Comment Resolution for Shared Ground Topic (comment i-55, i-61, i-66, i-67)

Kent Lusted, Intel Corporation, P802.3ck Vice-Chair Matt Brown, Huawei, 802.3ck Editor-in-Chief

Comment Overview

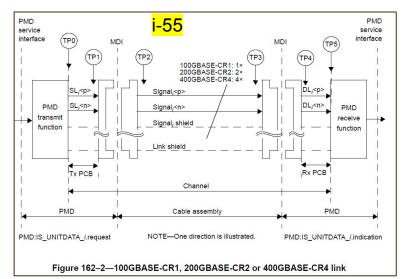
The text says "For 100GBASE-CR1, 200GBASE-CR2, and 400GBASE-CR4, the lanes are AC-coupled. The AC-coupling shall be within the cable assembly". It can be questioned which contacts are AC-coupled in the cable. Figure 162-2 shows signal shields and link shield in addition to the differential pairs, and there is no distinction, so can the shields also be AC-coupled? Are they even required to be connected on both ends?

My understanding is that in practice the shields are DC-coupled and provide a ground connection between both ends. This has importance in preventing the ground voltage from bouncing at either end and creating unexpected common-mode differences between Tx and Rx pairs (because common-mode voltage is referenced to ground).

This should be stated explicitly. The suggested remedy is to add it to 162.11 which seems to be a convenient place, but other places or phrasing are possible. It may be required to add some specifications to the MDI as well.

Insert a paragraph after the one starting with the quoted text (lines 11-16) with the following

"The signal shield and link shield are connected to the corresponding contacts in the MDI plug connectors on both ends of the cable assembly".

PROPOSED ACCEPT IN PRINCIPLE.

Insert a paragraph after the one starting with the guoted text (lines 11-16) with the following text: The signal shields are connected to the corresponding contacts in the MDI plug connectors on both ends of the cable assembly.".

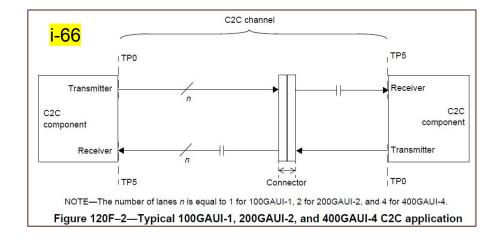
The link block diagram does not show a ground connection, and there is no requirement anywhere in annex 120F that the devices on both ends of the link have a common ground connection.

If there is no common ground, or ground connection is poor, the Tx common-mode specifications may become meaningless, because the common-mode voltage on each device is defined with different grounds.

If a ground connection is added in this figure, it should also be noted that each arrow represents a differential pair, or alternatively draw two lines in each direction, as done in Figure 163-2.

Add an additional line in each direction to represent a differential pair, and add a ground connection between the devices to the diagram.

Change the paragraph on P237 L40-42, inserting a sentence about the ground connection, as follows:

"The 100GAUI-1, 200GAUI-2, or 400GAUI-4 C2C bidirectional link is described in terms of a C2C transmitter, a C2C channel, and a C2C receiver, which have a shared ground connection. Figure 120F-2 depicts a typical C2C application."

PROPOSED ACCEPT IN PRINCIPLE.

Proposed changes to the figure is cumbersome and may imply a parti New text pointing out the common ground is sufficient.

Add text that a common ground is expected with editorial license. For task force discussion.

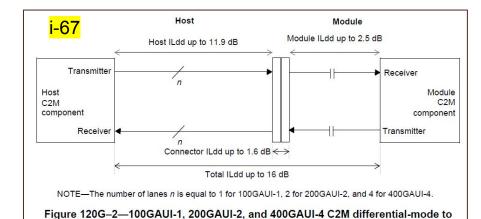
Comment Status D ground connection The link block diagram does not show a ground connection, and there is no requirement

anywhere in annex 120G that the devices on both ends of the link have a common ground

If there is no common ground, or ground connection is poor, the output common-mode specifications and input common-mod tolerance may become meaningless, because the common-mode voltage on each device is defined with different grounds.

If a ground connection is added in this figure, it should also be noted that each arrow represents a differential pair, or alternatively draw two lines in each direction, as done in Figure 163-2.

Add an additional line in each direction to represent a differential pair, and add a ground connection between the devices to the diagram.

Change the first sentence in the paragraph on P256 L7-14, inserting a sentence about the ground connection, as follows:

"The C2M link is described in terms of a host C2M component, a C2M channel with associated differential-mode to differential-mode insertion loss (ILdd), and a module C2M component, which have a shared ground connection."

PROPOSED ACCEPT IN PRINCIPLE.

Proposed changes to the figure is cumbersome and may imply a particular implementation. New text pointing out the common ground is sufficient.

Add text that a shared ground is expected with editorial license.
